Service-Information Motorcycle

Group: 36
Wheels & Tires

January, 1987
36 036 86
(2236)

Tire Valve Stems - All Tubeless Tire Models

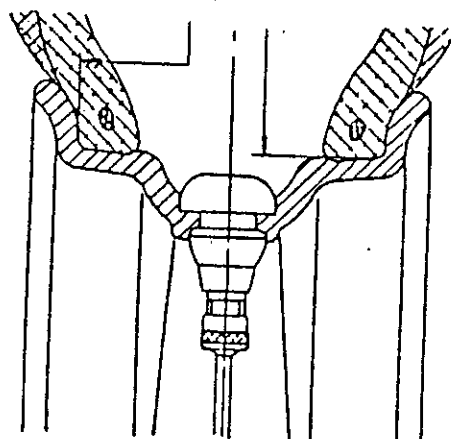
The threaded-type valve assembly used on early production tubeless tire rims has been replaced with a rubber valve similar to the one used on automotive rims.

The two versions **cannot** be interchanged, as the rims have been modified accordingly. Please make sure your Parts Department and Service Technicians are informed of these changes. Most replacement wheels ordered from our Parts Department will employ the new rubber valve stem system. Therefore, be sure to order a replacement valve stem when ordering a new wheel.

part No. 36 32 1 451 242

part No. 36 31 1 454 963
